MEMO

TO: Lashta Haidari, Steven Findlay
FROM: Ody Murlianto, Richard West, Ryan Miller
SUBJECT: Meriton Dee Why Review of Traffic Matters
OUR REF: 2196969A-ITP-MEM-RPT RevA.docx
DATE: 28 March 2017

Northern Beaches Council has engaged WSP | Parsons Brinckerhoff to undertake a review of the Traffic Impact Assessment undertaken to support the Development Application submission for the subject development.

Notes

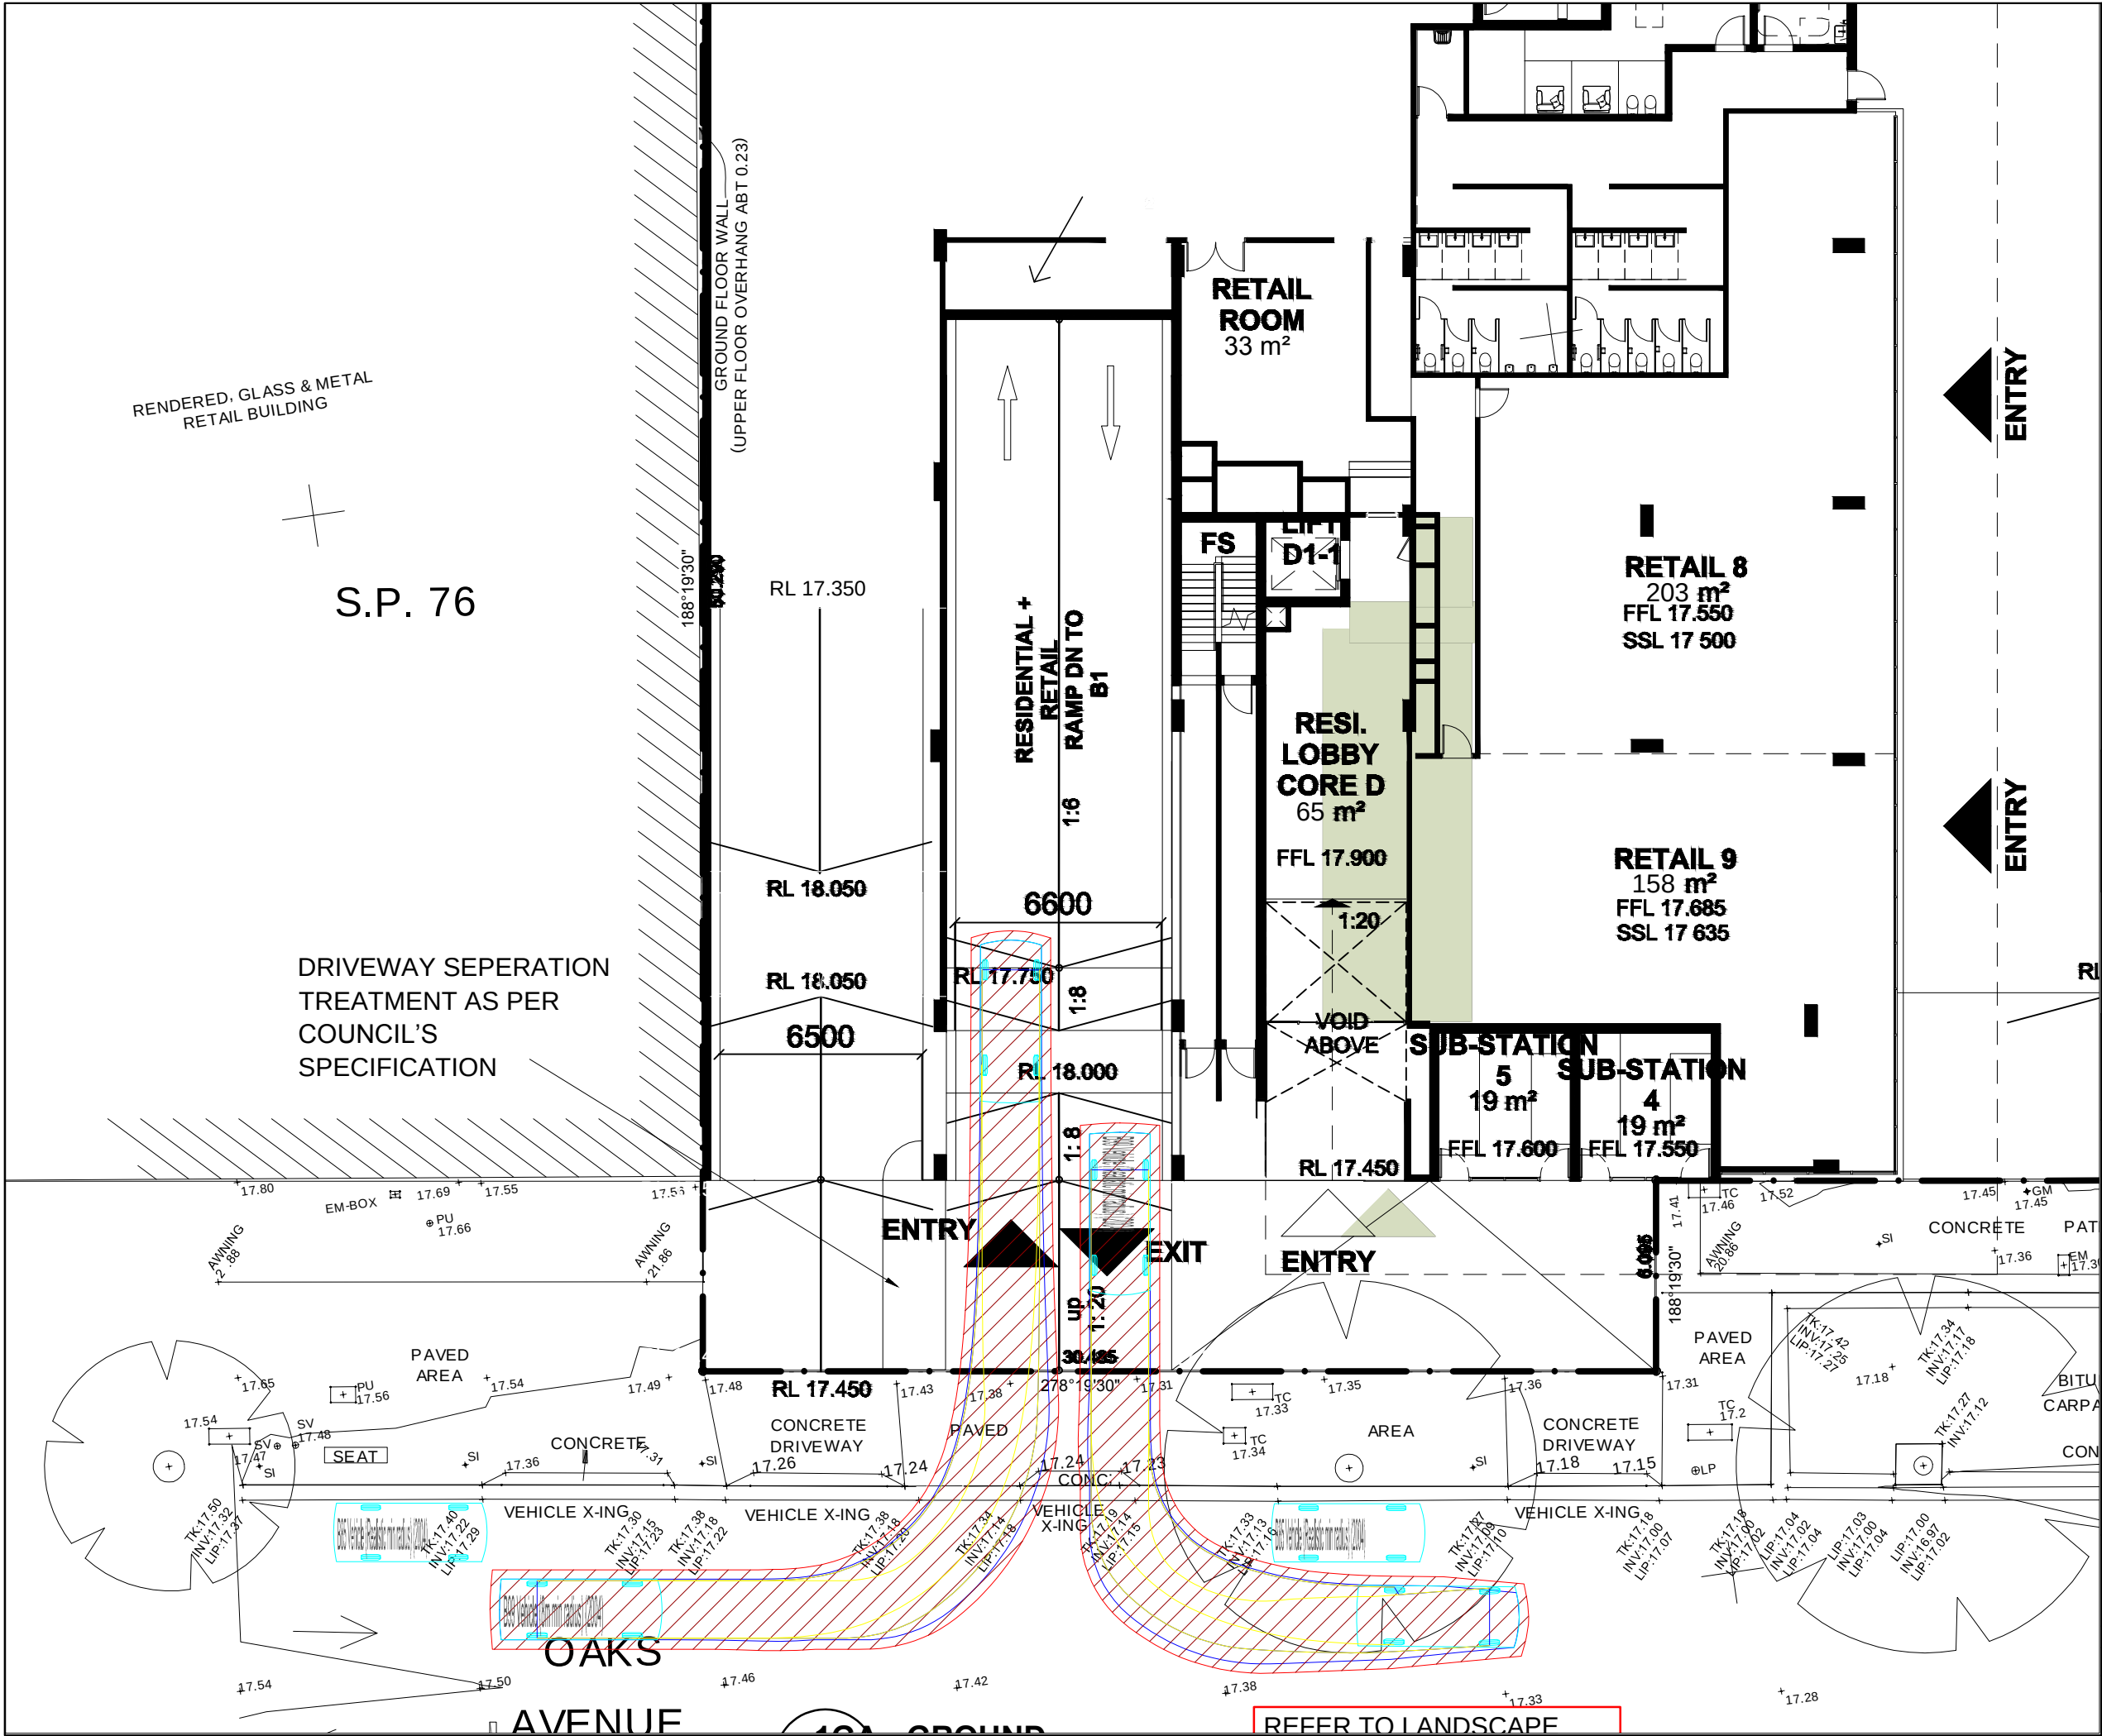
Reviews undertaken on 21 November 2016 and 8 February 2017 raised a pedestrian safety issue associated with the locations of the driveways to the car park, loading dock and neighbouring property's access driveway which would require pedestrians to cross a driveway crossing in excess of 20 metres wide. To put it into perspective, a typical wide collector road is approximately 12.8 metres wide.

It was agreed that to reduce the length of the pedestrian crossing, a driveway separation be installed between the access driveway to the loading dock and the access driveway to the basement car park. The implementation of this treatment was agreed for both driveways at Oaks Avenue and Howard Avenue and are considered satisfactory to achieve the objective of reducing the crossing distance at which pedestrians are required to cross at both access driveways. A copy of the amended drawings and the relevant turning path assessments undertaken by Traffix can be found in Attachment C.

REFER TO LANDSCAPE
ARCHITECT DWGs FOR
ROAD SERVICE FINISHES

DRIVEWAY SEPERATION
TREATMENT AS PER
COUNCIL'S
SPECIFICATION

Overhead Clearance Assessment (24 Traffix, March 2017)

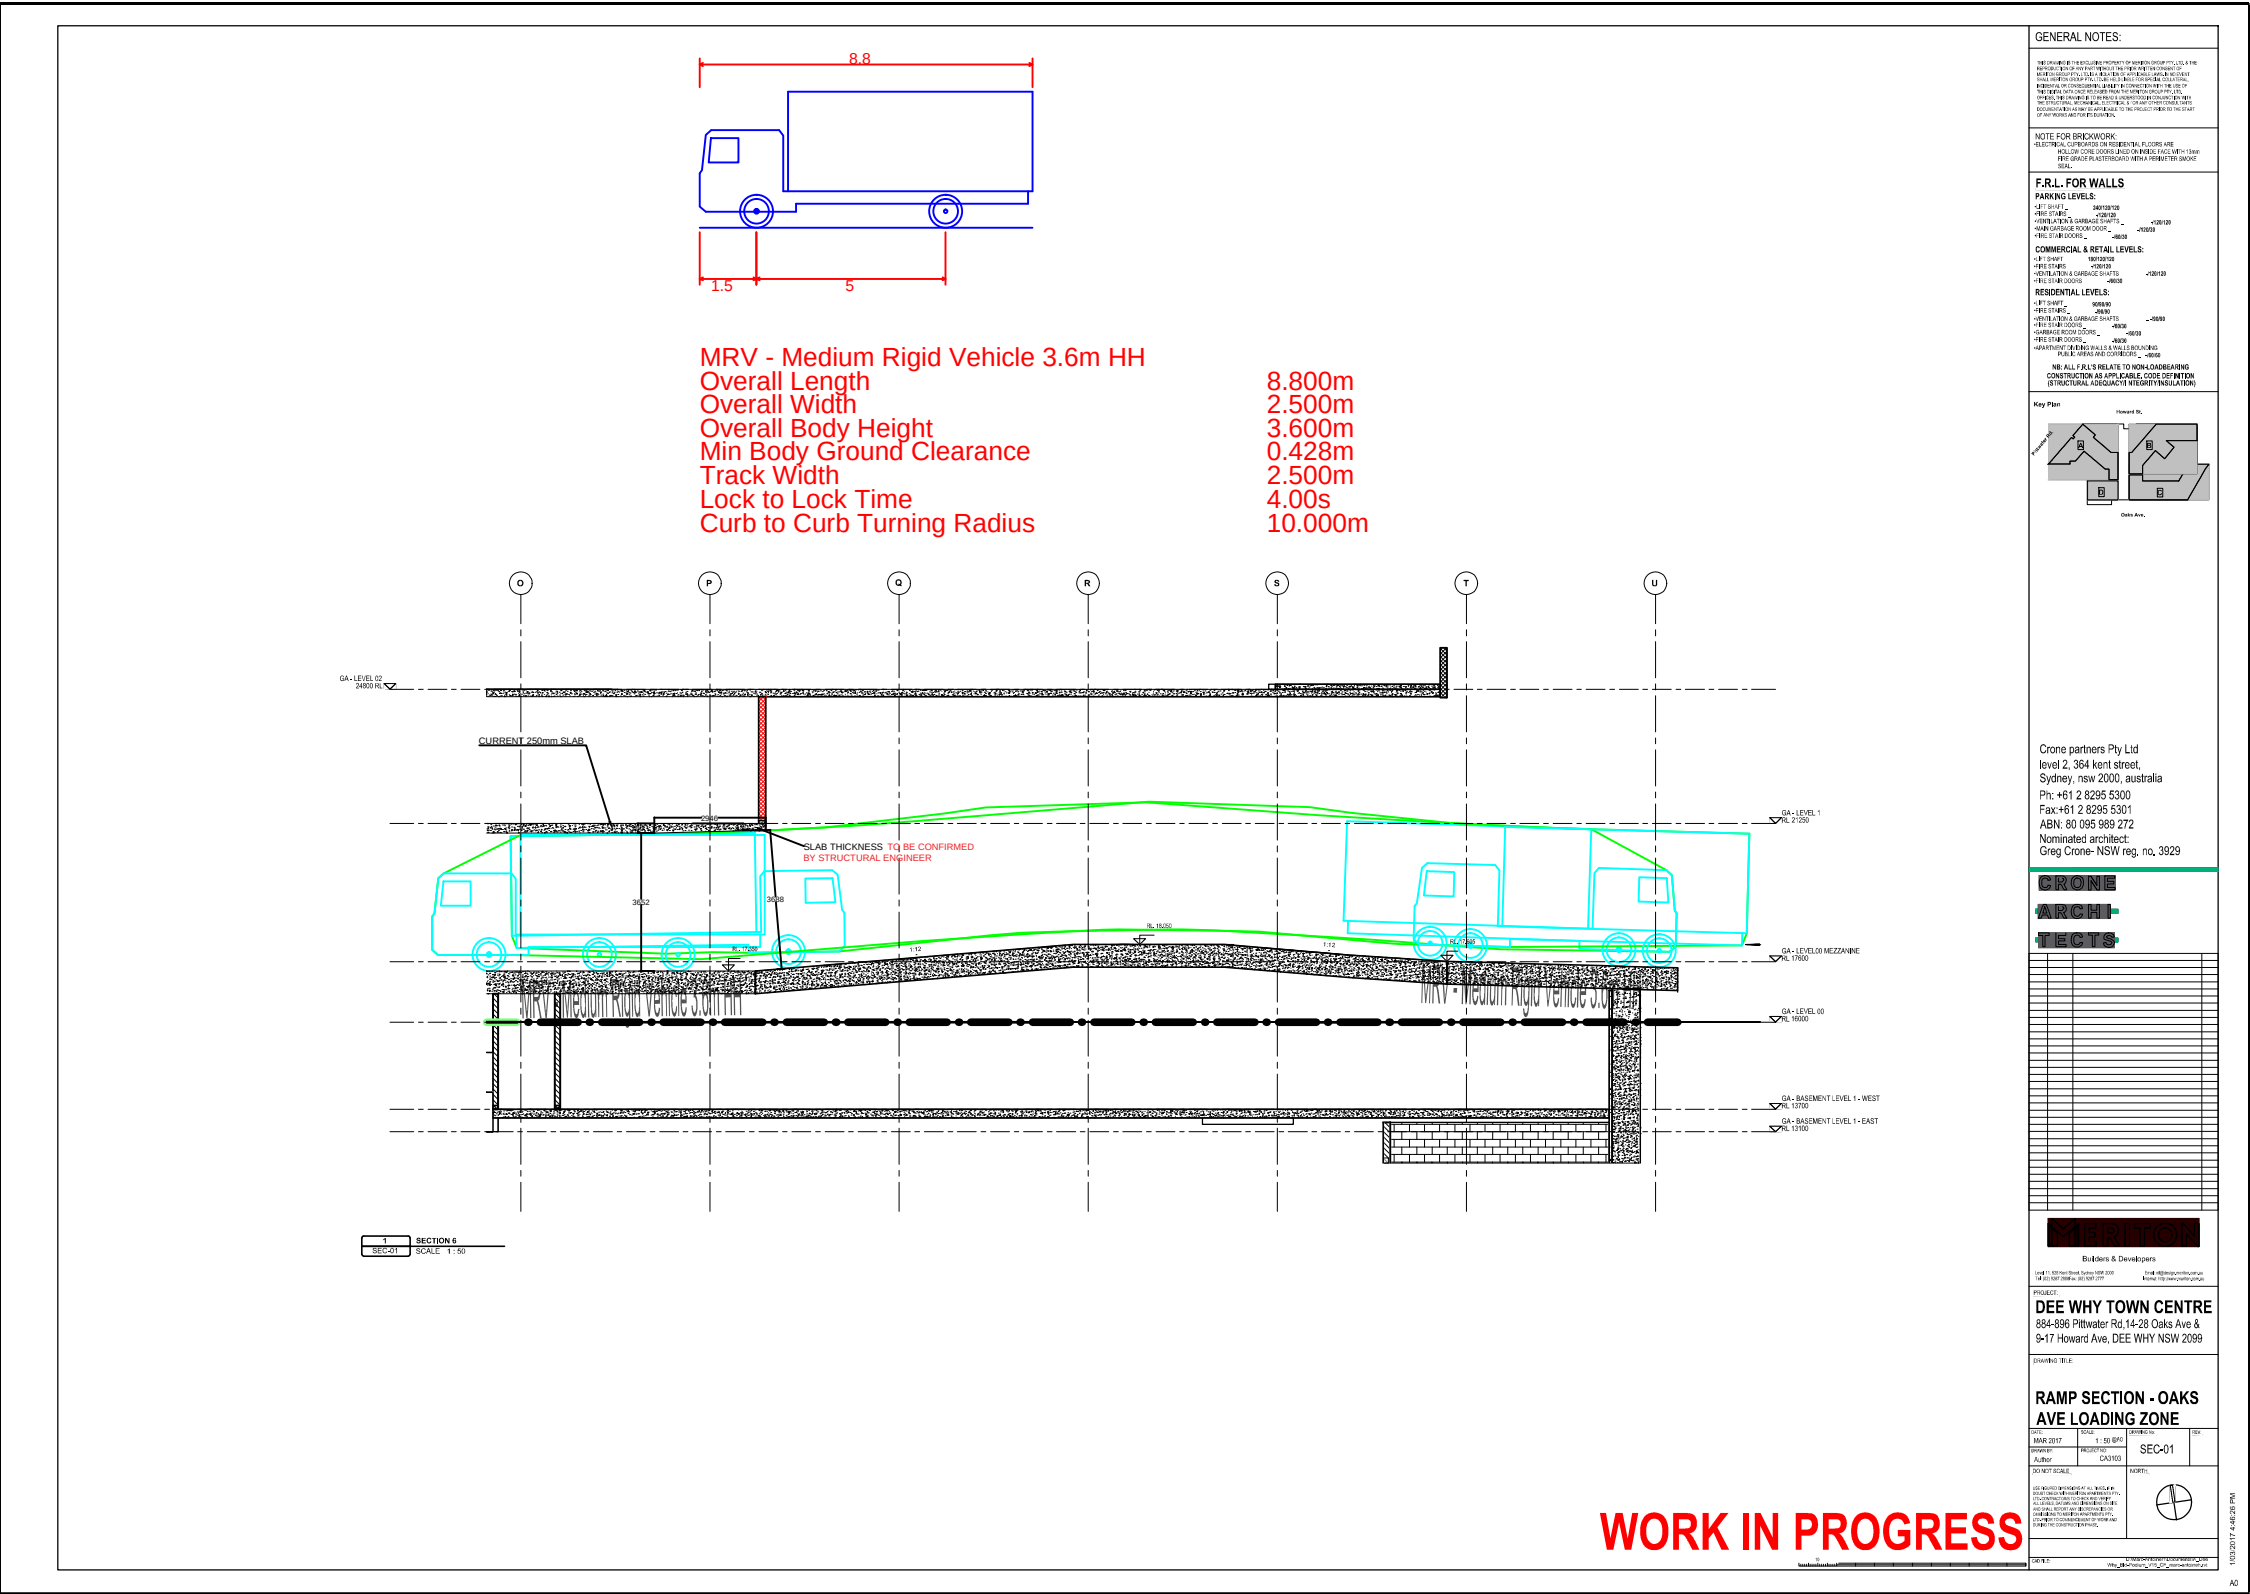
An issue was raised with regards to the non-compliance of the overhead clearance proposed at the loading dock at Oaks Avenue. The largest design vehicle of a Medium Rigid Vehicle (MRV) was selected in a number of turning path assessments submitted for review including the drawings prepared on 17 February 2017. The minimum overhead clearance required for a Medium Rigid Vehicle is 4.5 metres as per Table 2.1 of AS 2890.2:2002.

The overhead clearance proposed for the development was measured at 3.286 metres. This was later reviewed to show 3.615 metres in the drawing (Ref: Sec-01) prepared by the Applicant in March 2017.

It was noted that the loading dock will also consist of garbage rooms and provide access for the delivery to the retail developments of the westernmost building blocks of the development. A non-compliance of the overhead clearance would result in loading/unloading and the servicing of the development to be carried out on-street.

The Oaks Avenue loading dock has been provided with a head height clearance of 3.6m. The ramp grades and geometry is fully compliant (sic) with AS2890.2 (2002). Vertical clearance tests have also been undertaken using an MRV (with a reduced head height of 3.6m) and show satisfactory operation of the loading dock entry ramp with no head height or bottom scraping. The vertical clearance tests are presented in Appendix B.

Architectural design has been proposed to suit the 3.6 metres overhead clearance and is shown in drawing number TX.01 prepared on 21 March 2017. A copy of the drawing is attached in Appendix E.

The response provided by the applicant in the report prepared on 22 March 2017 is considered in-line with the discussion held on 17 March 2017 to address the issues associated with the overhead clearance for the loading dock at Oaks Avenue to ensure its functionality.
